Service Bulletin

Bulletin No.: 24-NA-049

Subject: Information on Blazer EV Police Vehicle Air Deflector Installation

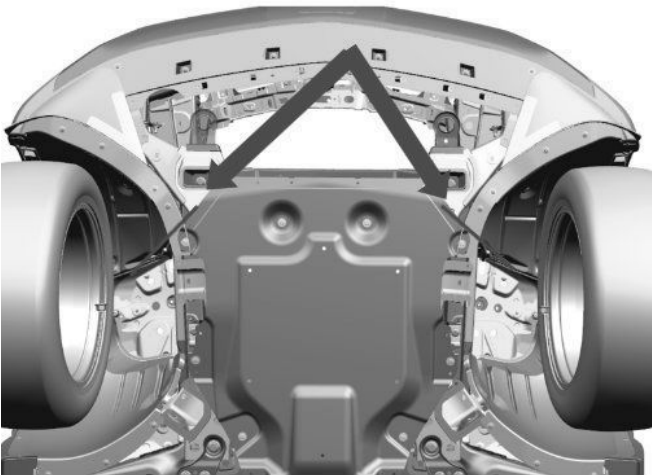
Involved Region or Country	North America
Condition	On Blazer EV POLICE vehicles during PDI the dealer may find that the front air deflectors are too long and interfere with an underbody shield.
Cause	The cause of the condition may be due to the aero panel was added after the air deflectors were developed.
Correction	Trim the air deflectors like illustrated below.

If you encounter a vehicle with the above concern, trim the air deflectors in the locations illustrated below.
